# Discussion on increasing the Schnupp asymmetry

A preliminary document exploring allowable ETM's & ITM's mechanical clearances along the beam center line & the feasibility of cookie cutter 'BLANKS' for the following chambers:

# Discussion on increasing the Schnupp asymmetry

# WBSC1, LBSC1 (ITMy)

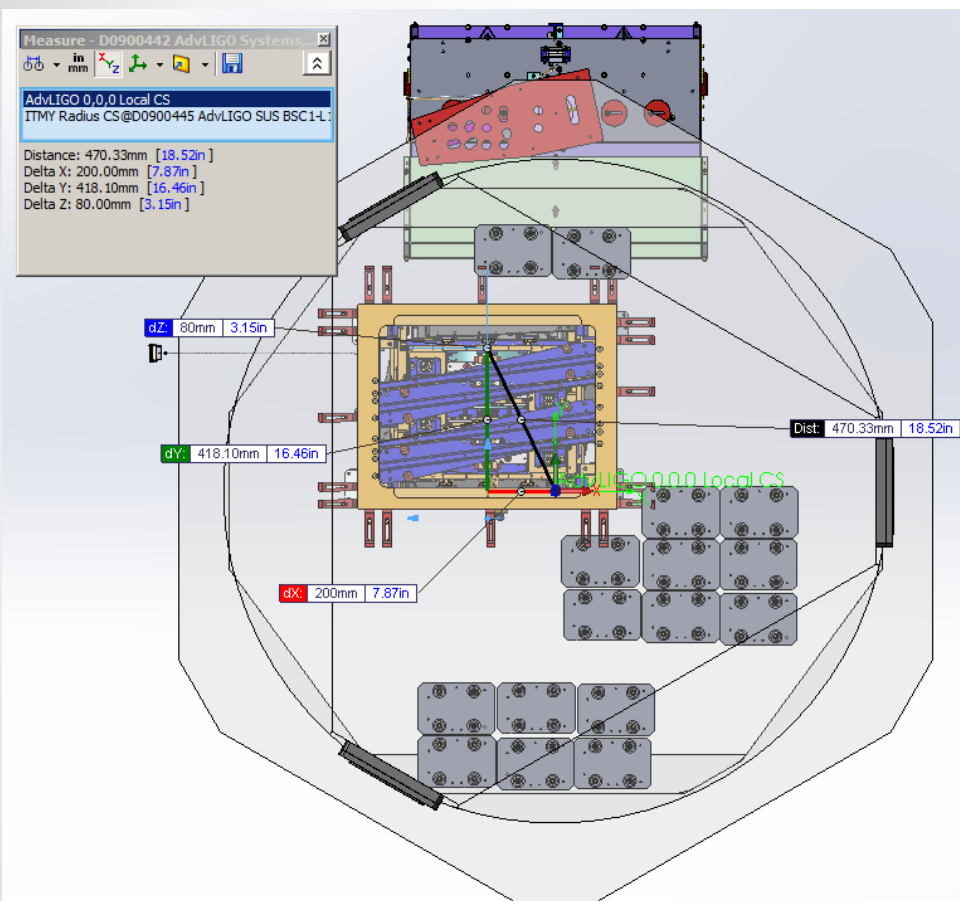
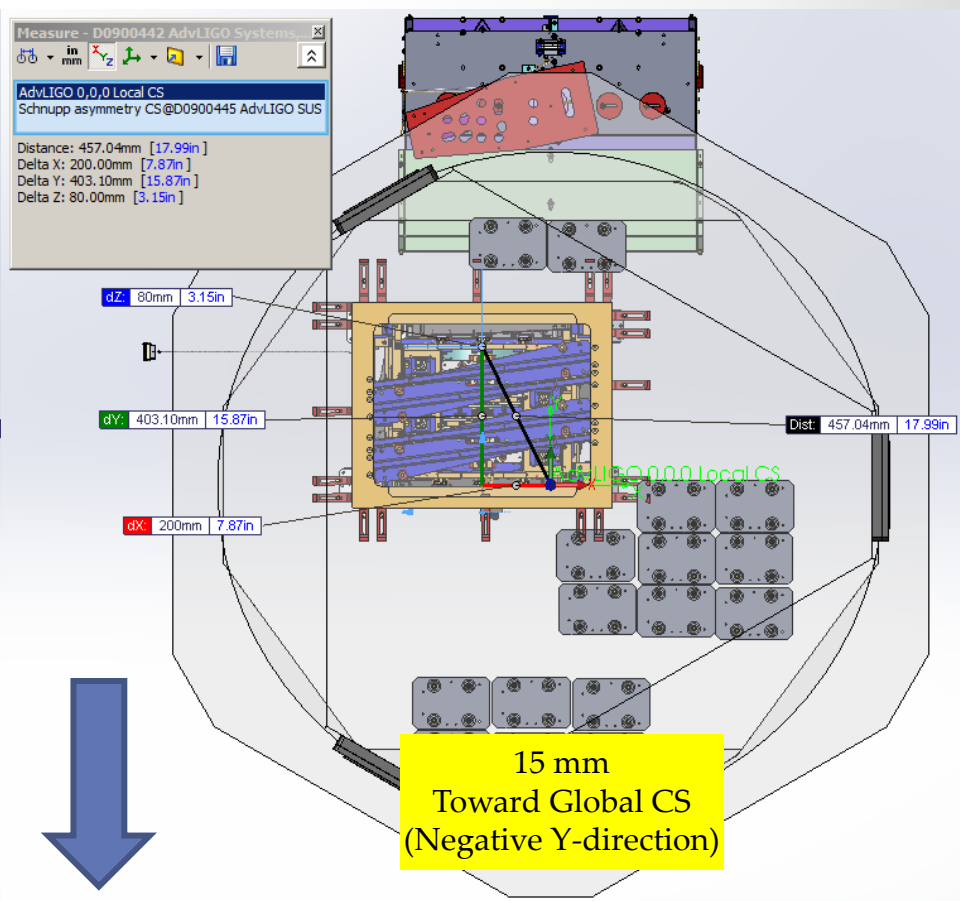
Considerations about increasing the Schnupp Asymmetry on ITMy (WBSC1 & LBSC1) by 15 mm toward the Global CS :

- The ITMy will be moved 15 mm in the opposite direction of ACB.  
(However the ACB may need to be enlarged to get closer to the ITMy.)

- TCS may need to re-align this mirror to work with the new position of the ITMy.

Local Coordinates:  
 $X = -200.0 \text{ mm}$   
 $Y = 418.10 \text{ mm}$   
 $Z = -80.0 \text{ mm}$

Local Coordinates:  
 $X = -200.0 \text{ mm}$   
 $Y = 403.10 \text{ mm}$   
 $Z = -80.0 \text{ mm}$

# WBSC3, LBSC3 (ITMx)

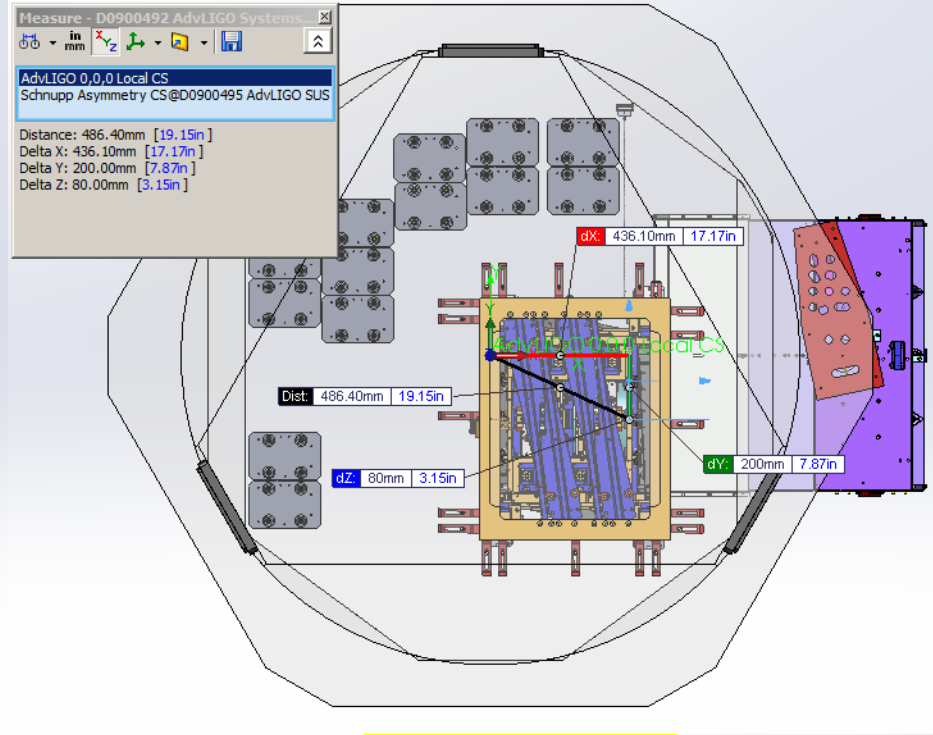
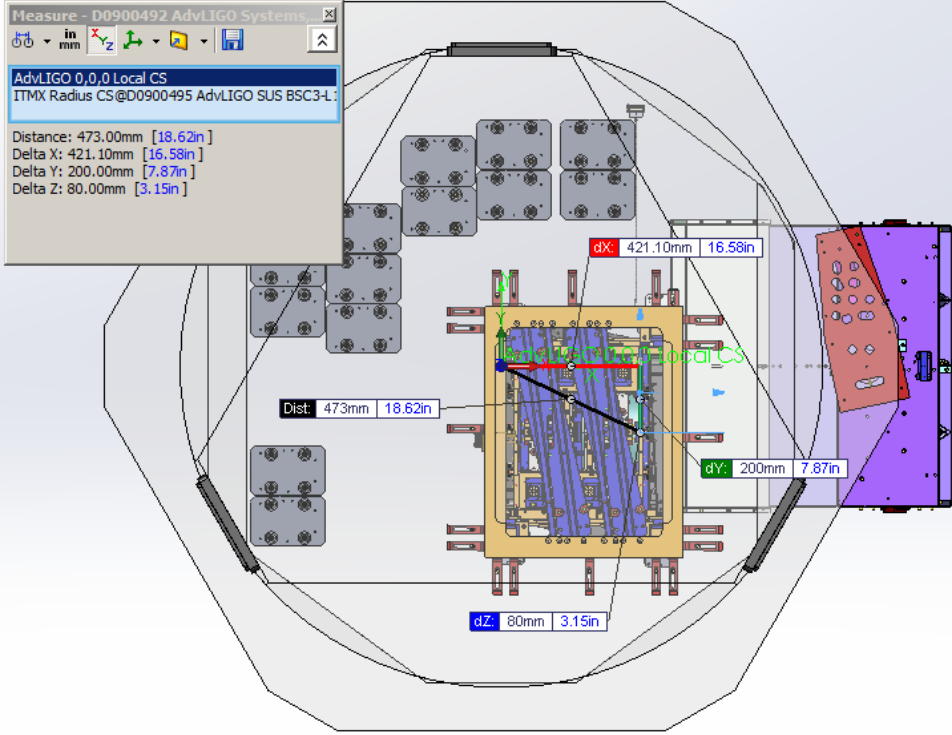
Considerations about increasing the Schnupp Asymmetry on ITMx (WBSC3 & LBSC3) by 15 mm away from the Global CS :

- The ITMy will be moved 15 mm away from Global CS (toward ACB)  
(ACB may need to be shortened by 15 mm, to keep same gap with ITMx).

- TCS may need to re-align this mirror to work with the new position of the ITMx.

15 mm  
Away from Global CS  
(Positive X-Direction)

Local Coordinates:  
X = 421.0 mm  
Y = -200.0 mm  
Z = -80.0 mm

Local Coordinates:  
X = 436.0 mm  
Y = -200.0 mm  
Z = -80.0 mm

# WBSC9, LBSC4 (ETM<sub>x</sub>)

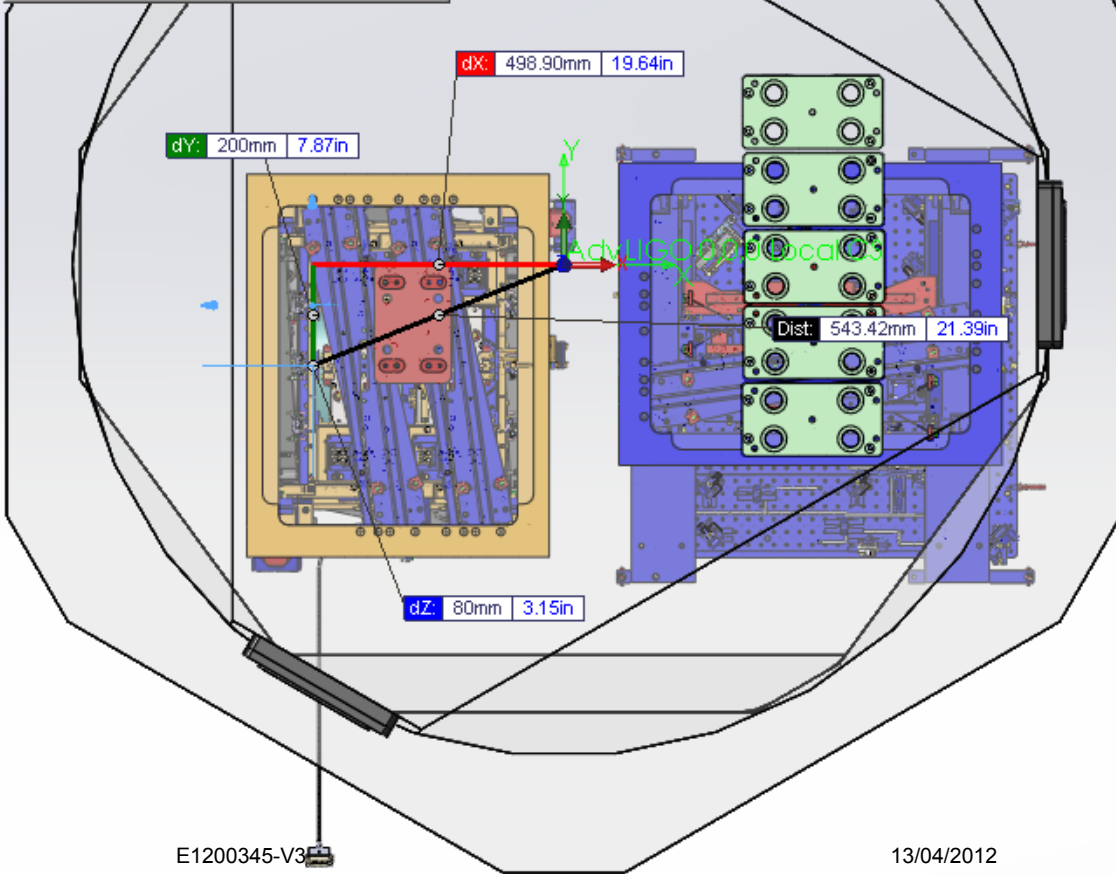
# NO CHANGE

# WBSC10, LBSC5 (ETMy)

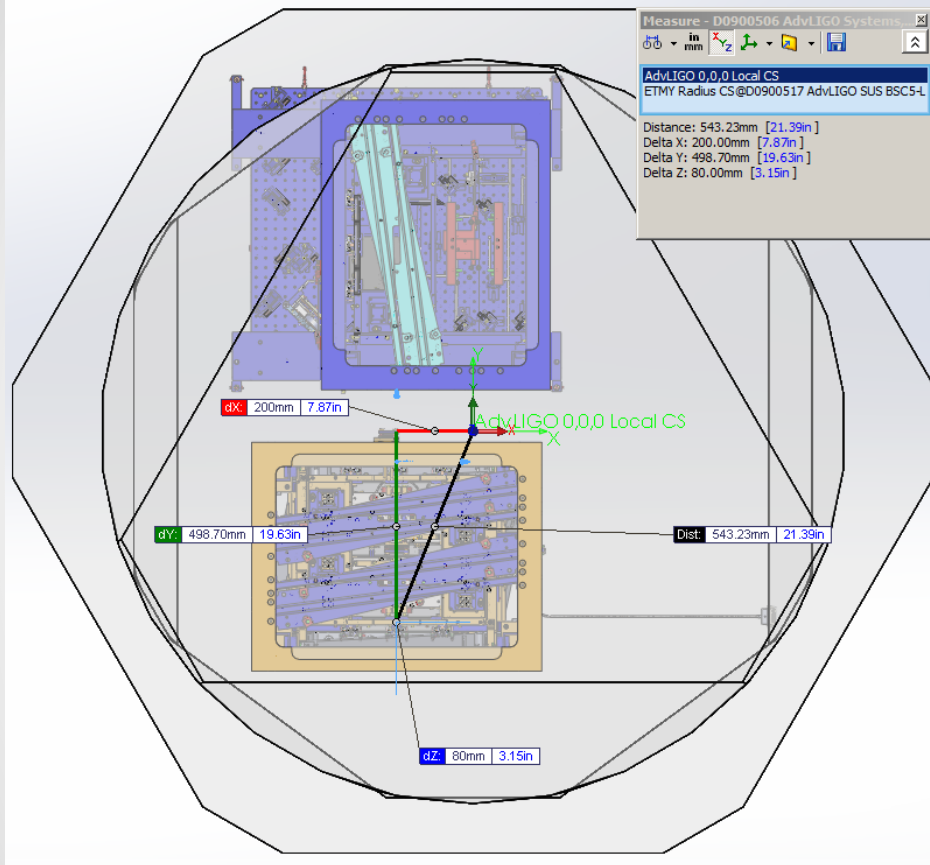
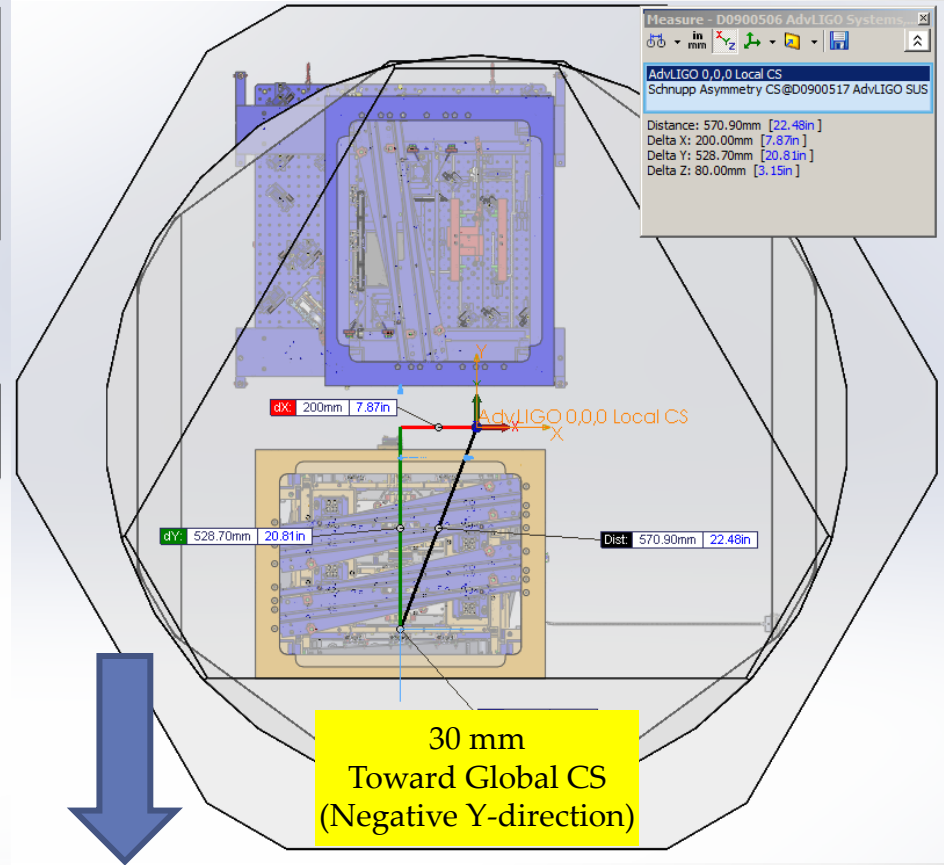
Considerations about increasing the Schnupp Asymmetry on ETMy (WBSC10 & LBSC5) by 30 mm toward the Global CS :

- There will be minor changes on the Dog clamp layout. ETMy will use the same Dog clamps but they will use some other available Hole locations for clamping.

- The ETMy will be moved 30 mm toward the Global CS (away from TMS). TMS may need to be moved to keep same gap with ETMy

Local Coordinates:  
 $X = -200.0 \text{ mm}$   
 $Y = -498.70 \text{ mm}$   
 $Z = -80.0 \text{ mm}$

Local Coordinates:  
 $X = -200.0 \text{ mm}$   
 $Y = -528.70 \text{ mm}$   
 $Z = -80.0 \text{ mm}$

## BSC3-L1 (ITMX)

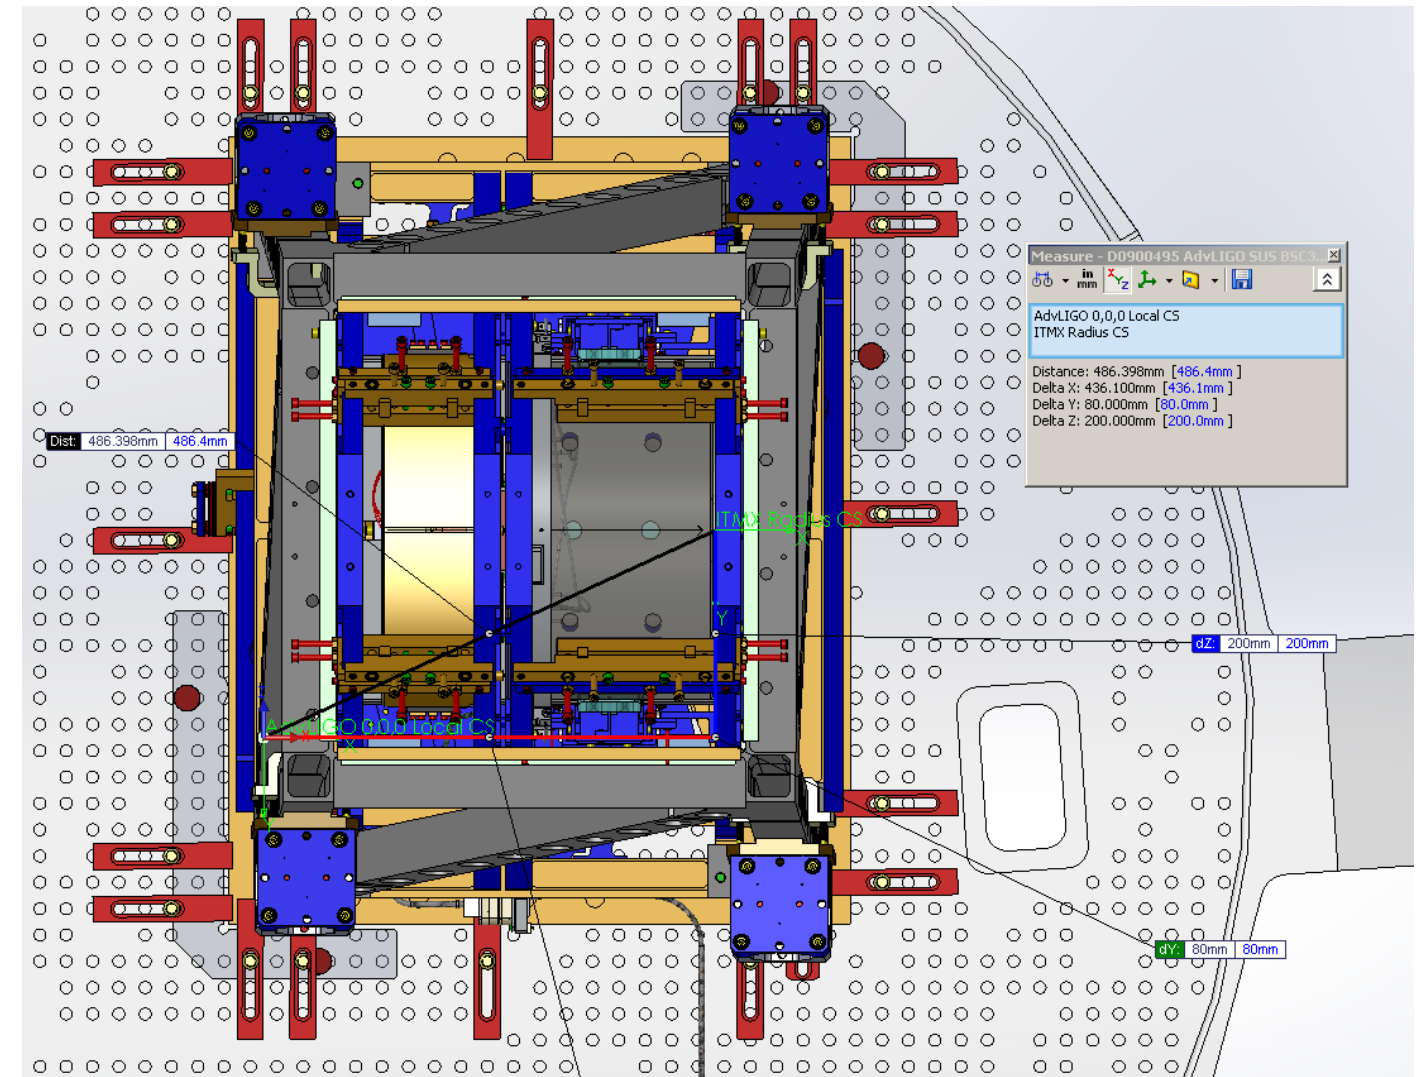
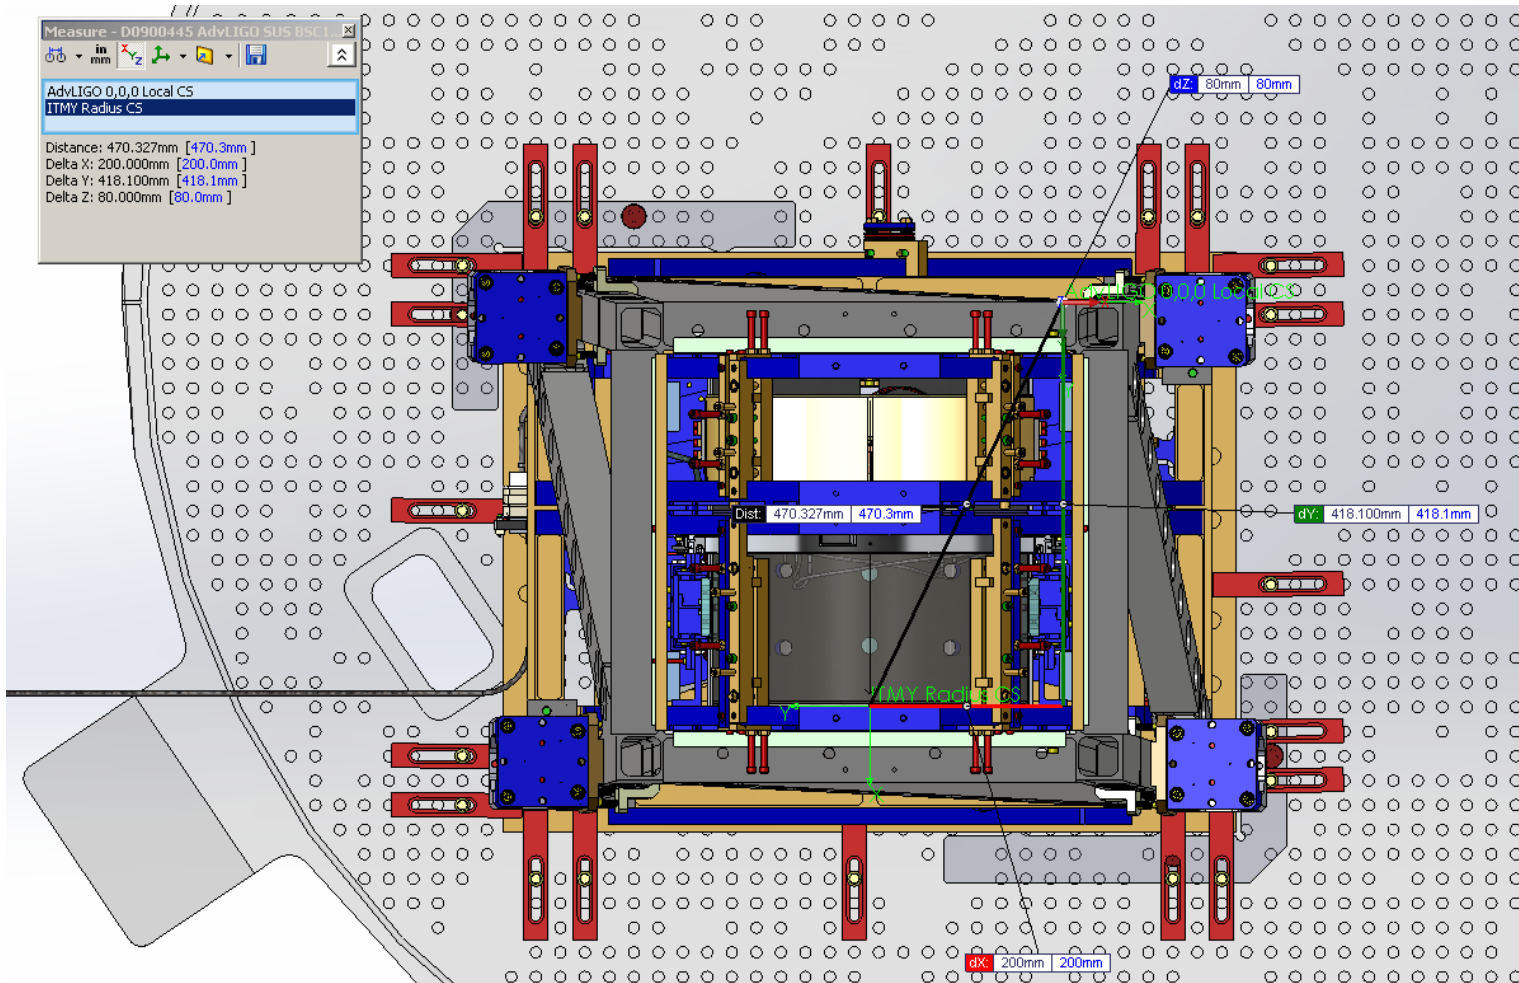
15mm AWAY FROM GLOBAL 0

Distance: 486.398mm [486.4mm]  
 Delta X: 436.100mm [436.1mm]  
 Delta Y: 80.000mm [80.0mm]  
 Delta Z: 200.000mm [200.0mm]
